CAUI-4 CTLE Comments

CTLE Recommendations

Table 83D-7—Reference CTLE coefficients

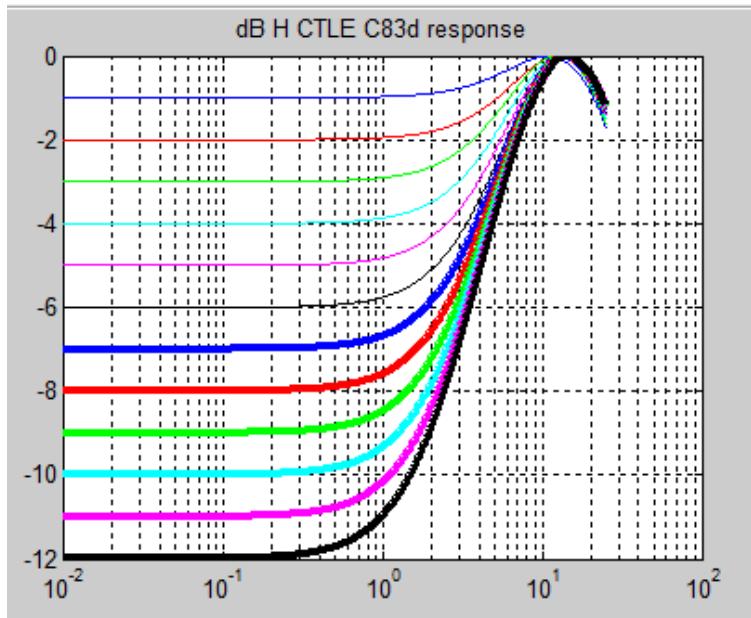
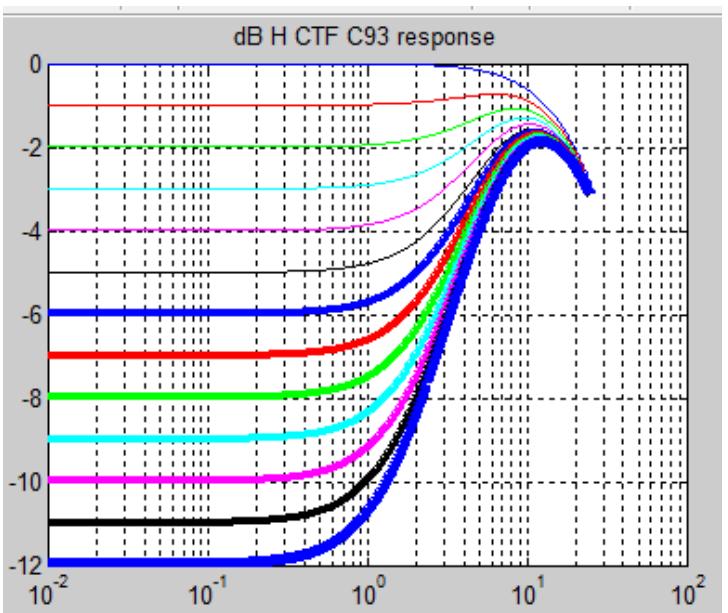
- Clause 83d CTLE not intended for DFE
- Clause 93a CTLE is intend for use with DFE
 - $\frac{1}{2}$ to 1 dB better COM
- Recommendation: Use 93a CTLE

Proposed changes

g_{DC}	f_{p1}	f_{p2}	f_z
-1	18.6 6.44	+++ 25.78	9.385 6.44
-2	18.6 6.44	+++ 25.78	8.937 6.44
-3	15.6 6.44	+++ 25.78	8.018 6.44
-4	15.6 6.44	+++ 25.78	7.861 6.44
-5	15.6 6.44	+++ 25.78	7.75 6.44
-6	15.6 6.44	+++ 25.78	7.67 6.44
-7	15.6 6.44	+++ 25.78	7.609 6.44
-8	15.6 6.44	+++ 25.78	7.566 6.44
-9	15.6 6.44	+++ 25.78	7.531 6.44
-10	15.6 6.44	+++ 25.78	7.503 6.44
-11	15.6 6.44	+++ 25.78	7.483 6.44
-12	15.6 6.44	+++ 25.78	7.466 6.44
